Addendum No. 1

Project: St. Patrick Catholic Church
Bid Set #2
6111 Morrill Avenue
Lincoln NE, 68507

Date Issued: January 13, 2014

Issued By: Brian Semerad, Project Manager
Kingery Construction Co.

AD.1

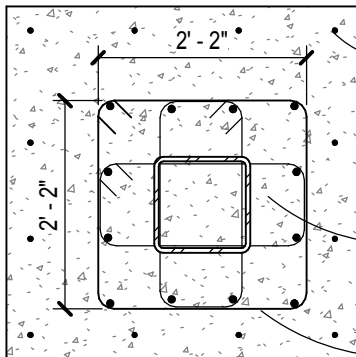
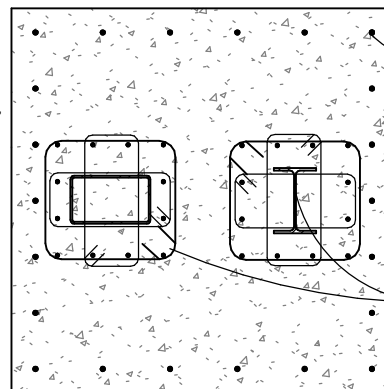
Item 8: Sheet S1.3 – Typical Details and Schedules.

- A. Replace the Concrete Pier Schedule with the attached schedule AD.1

E001-1

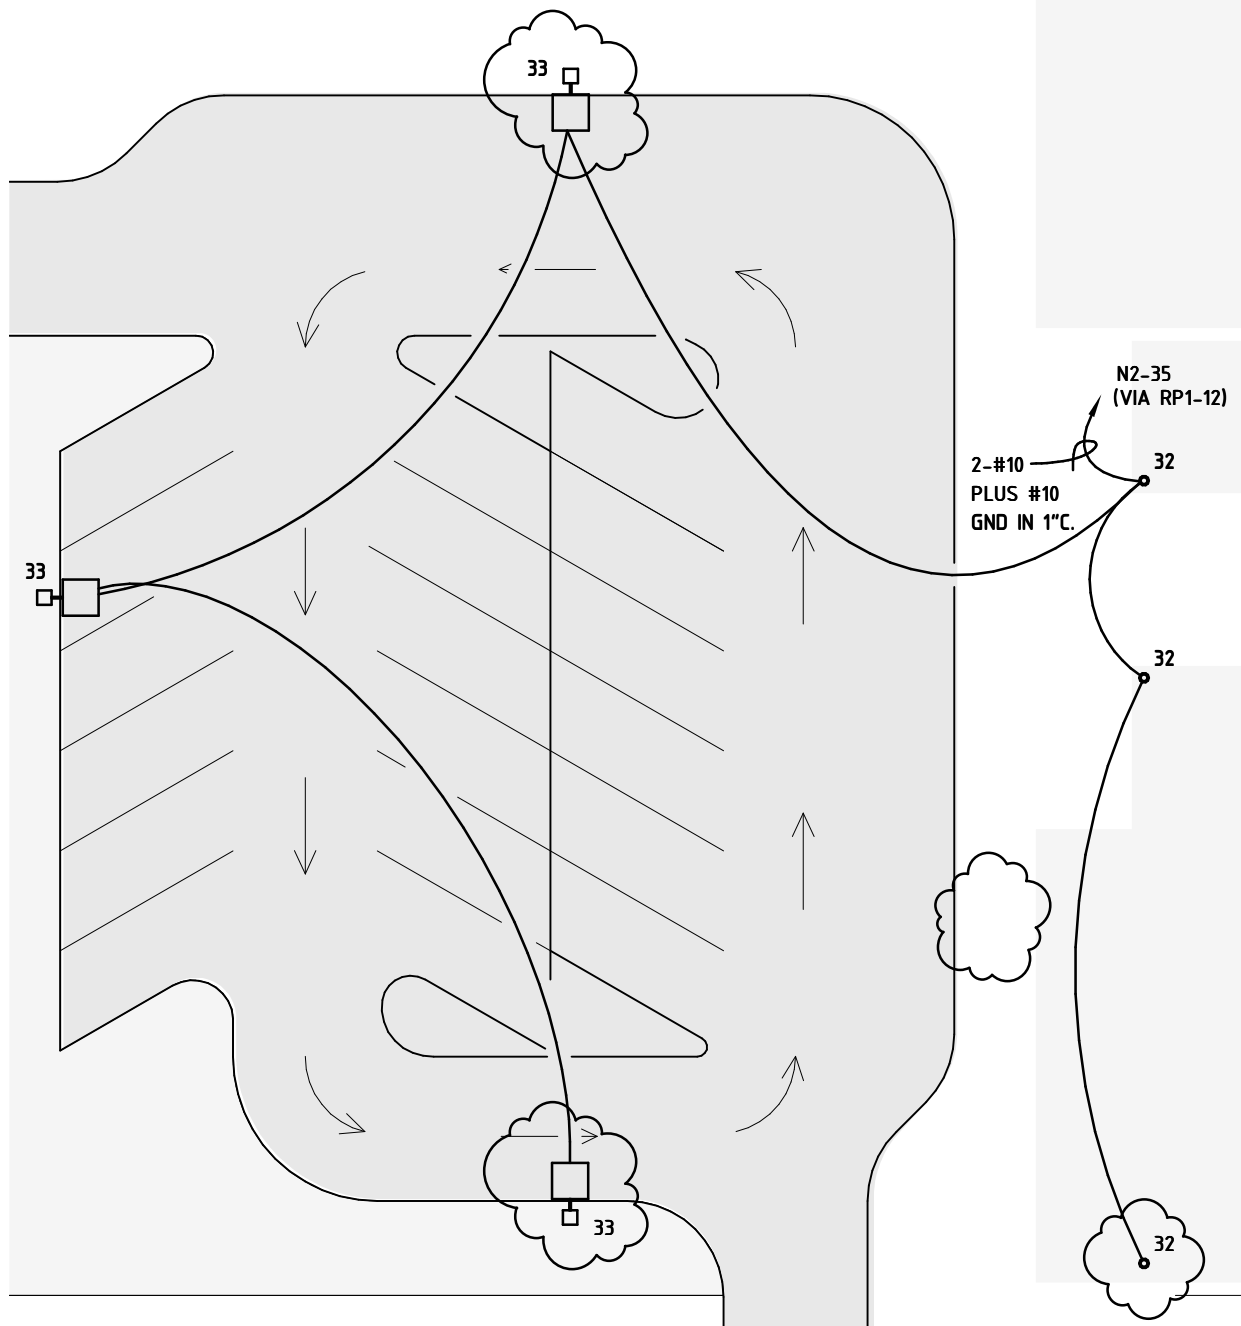
1. Provide an additional Type 32 pedestrian scale pole 60'-6" to the south of the south pole that was shown on the original drawings. Circuit with other pole lighting on circuit N2-35 via RP1-12. Refer to sketch E001-1 for updated layout and circuiting.
2. Delete the Type 33 pole luminaire on the east side of the parking lot and provide one Type 33 on the north end of the parking lot and one Type 33 on the south end of the parking lot. Refer to sketch E001-1 for updated layout and circuiting.

E101-1

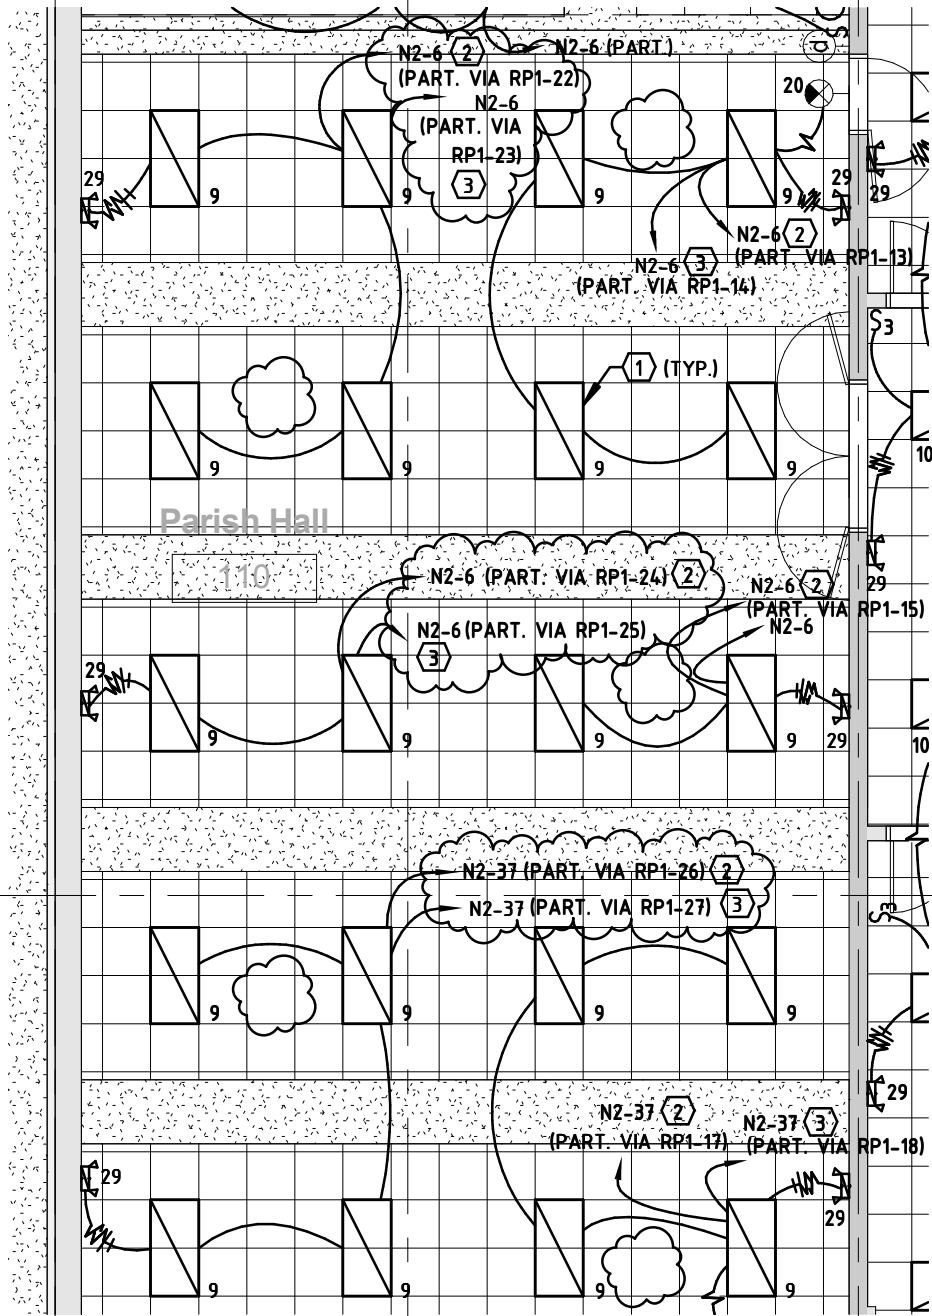
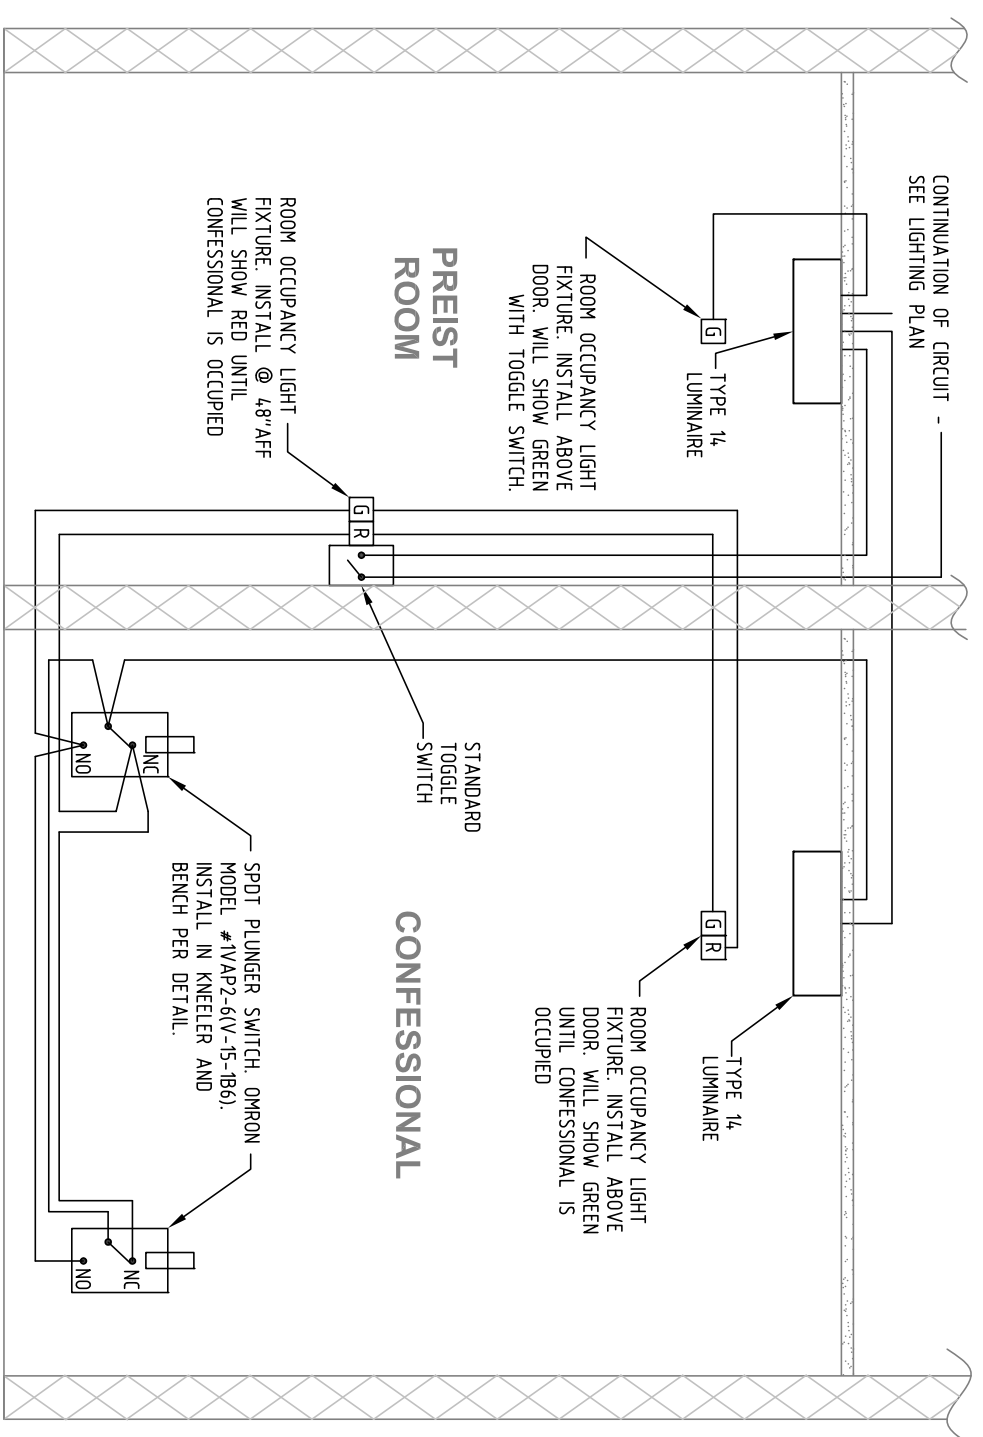
1. Delete (5) Type 'E' Occupancy sensors and keynote 4.
2. The two rows of luminaires closest to the west windows must be controlled by separate relays in order to met IECC requirements. Refer to sketch E101-1 for updated circuiting and notes.
3. Provide a total of two empty single gang J-boxes with $\frac{3}{4}$ " conduit stubbed to above accessible ceiling for future ceiling fan wiring. Provide with a blank coverplate over the box. The J-boxes shall be located at +48" A.F.F. adjacent to each of the Type 'd' lighting control stations in the space.

4. The luminaires on the north and south sides of the church must be controlled by separate relays in order to met IECC requirements. The south sconces originally on RP1-1 shall be circuited through RP1-28. The south Stations of the Cross luminaires originally on RP1-7 shall be circuited through RP1-29. The south side sconces originally on RP1-2 shall be circuited through RP1-30.
5. Provide (2) Type 'b' lighting control button stations. The second station shall be located adjacent to the original 'b' button station location. Each of these will be an 8 button station. Stations will be labeled 'b1' and 'b2'.

PARTIAL FIRST FLOOR - LIGHTING PLAN - ADDENDUM 1

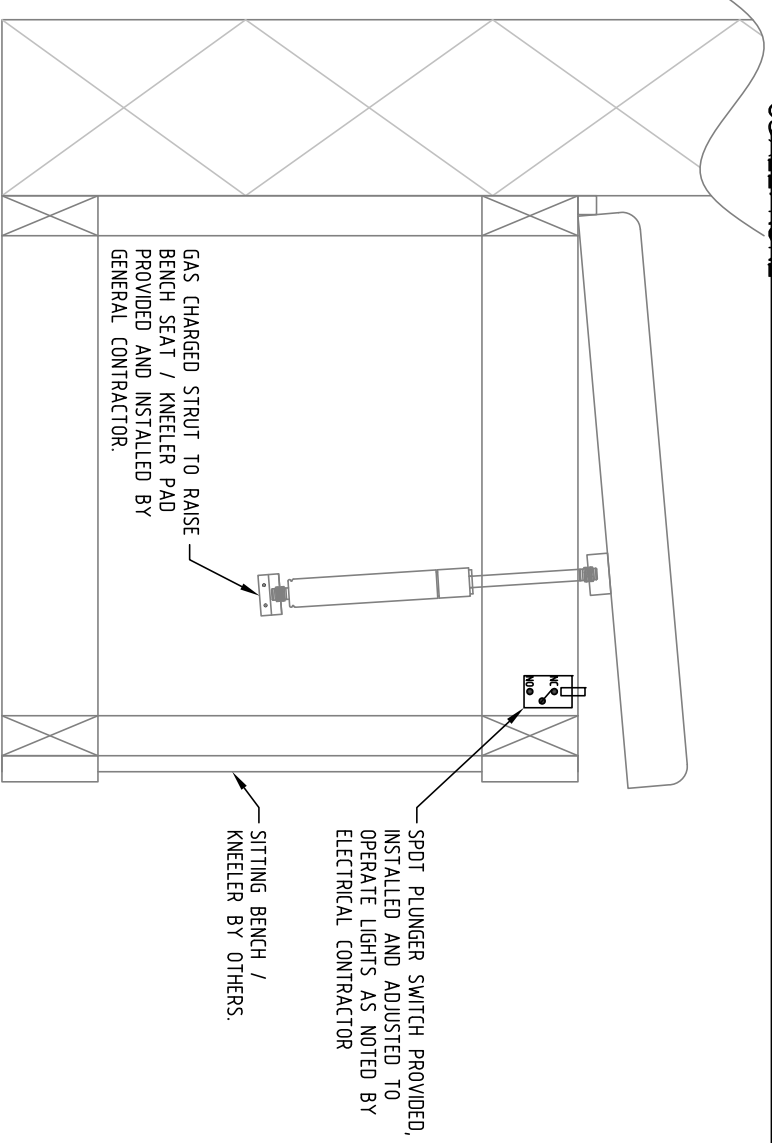
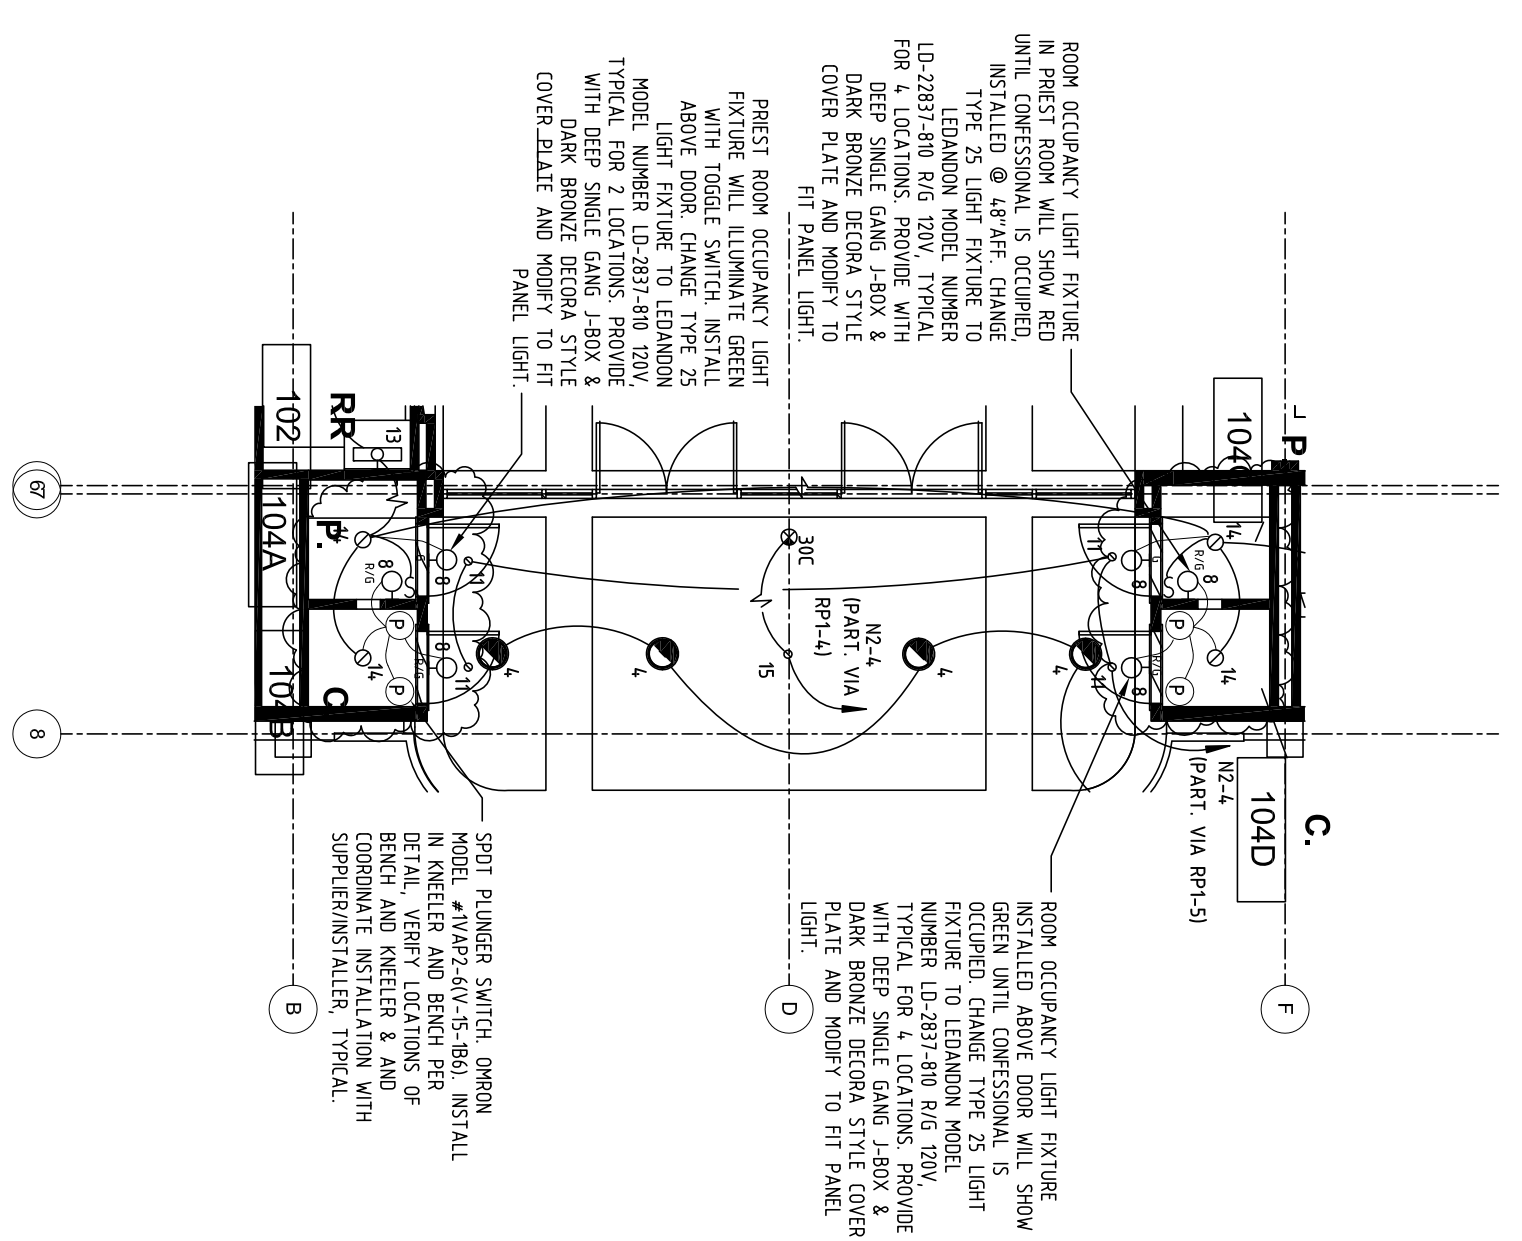
6. Refer to sketch E101-2 for updated layout, circuiting and notes.

E102-1

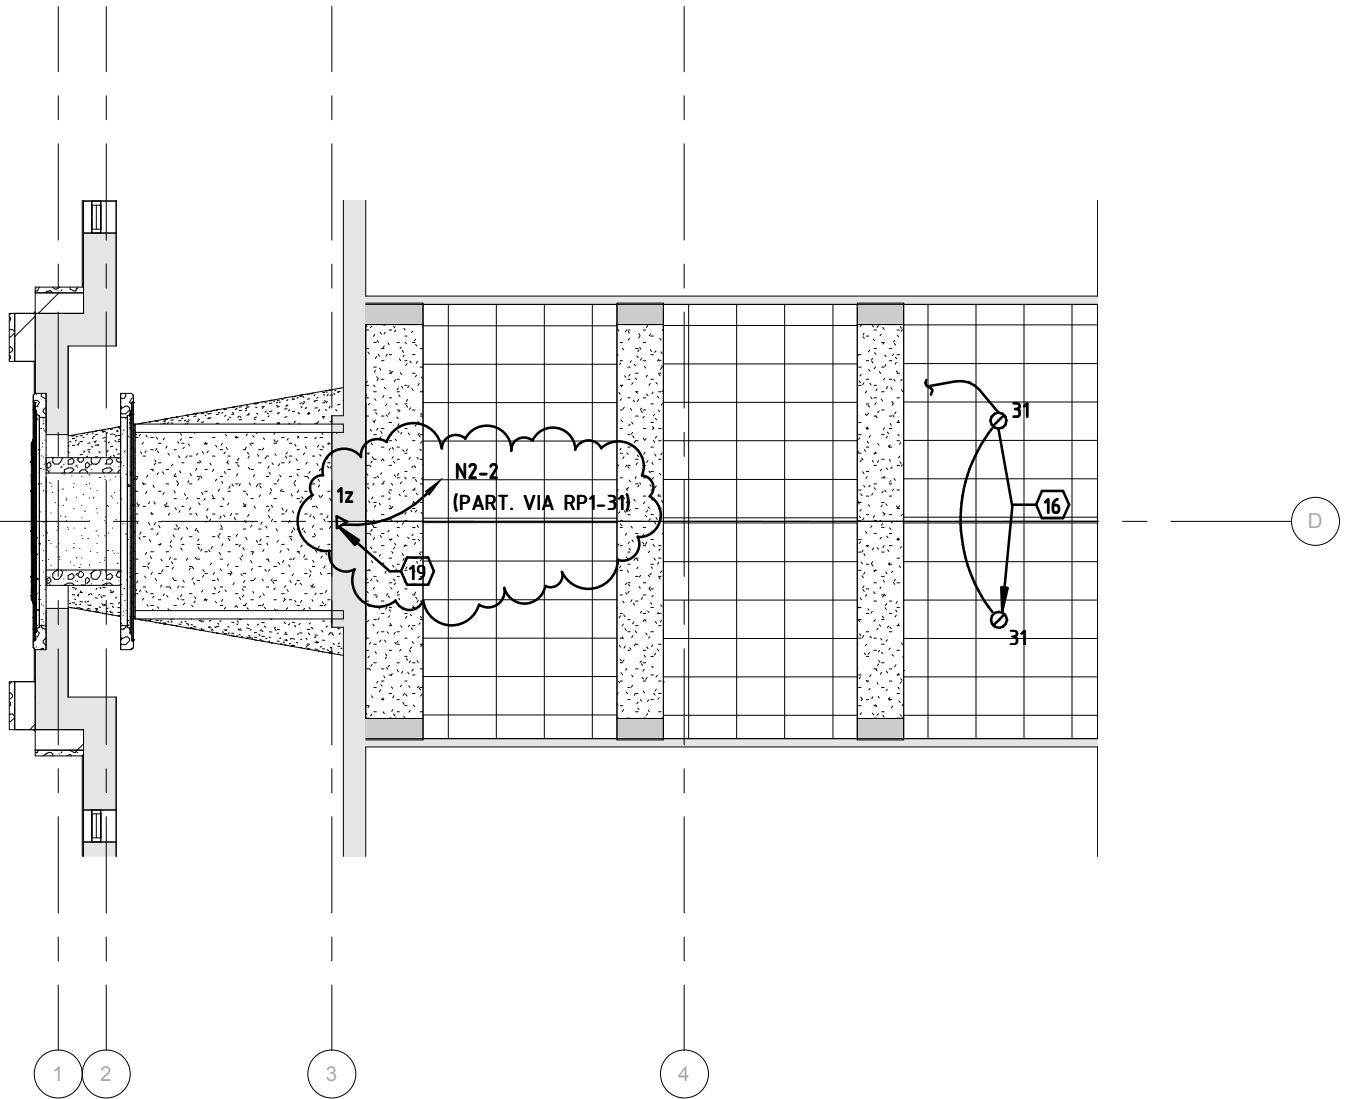
2. Add one Type 1z track head to illuminate the rose window in Narthex. Circuit to N2-2 via RP1-31. Apply keynote 20 which shall state: 'Luminaire monopoint shall be mounted on the bottom horizontal surface of the window ledge. Orient and aim luminaire to evenly illuminate window. Confirm exact luminaire placement with architect prior to installation'. Refer to sketch E102-1 for updated layout and circuiting.

1 RELAY ONE-LINE - ADDENDUM 1

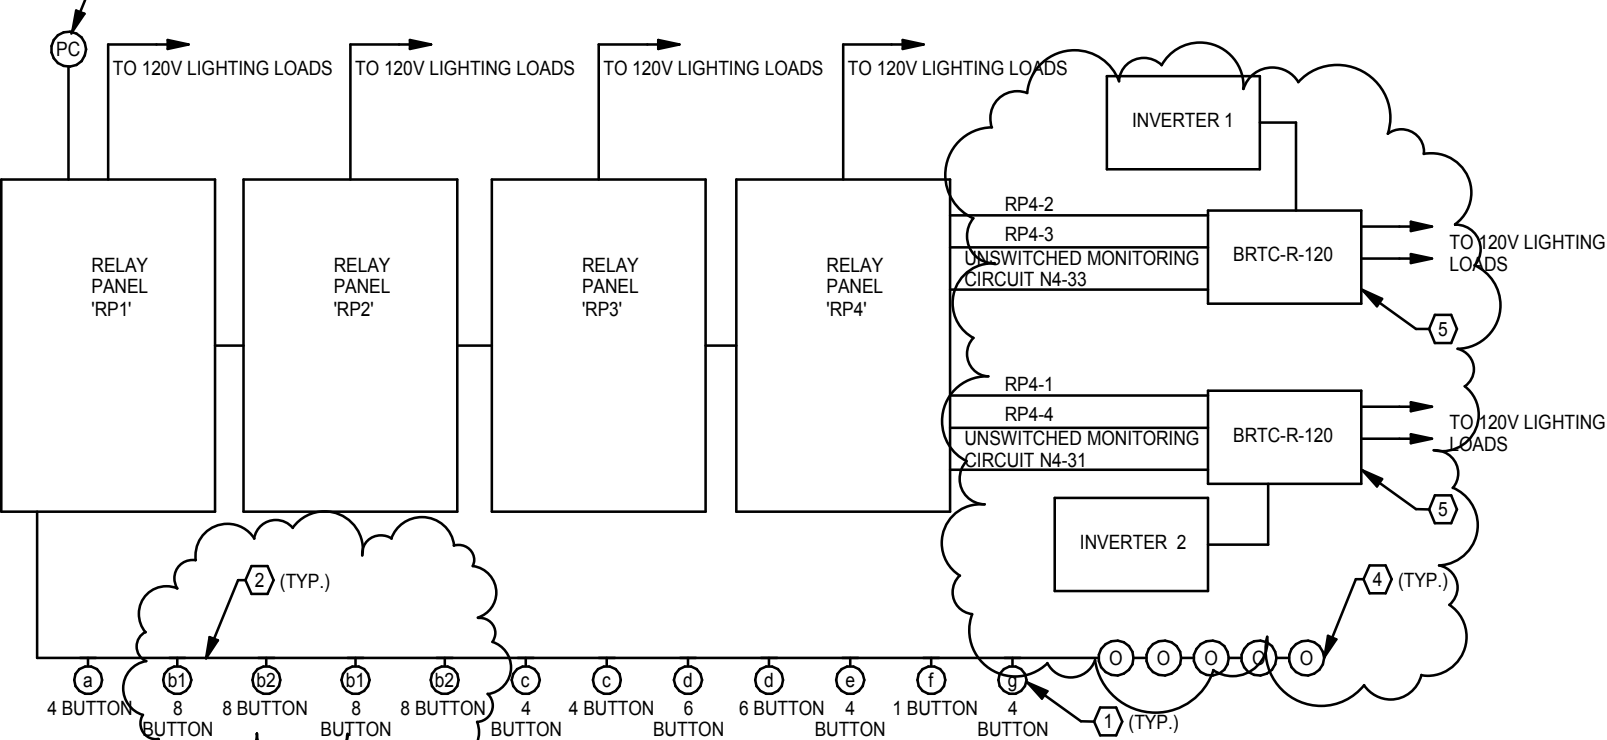
- Refer to sketch E401-4 for updated diagram.
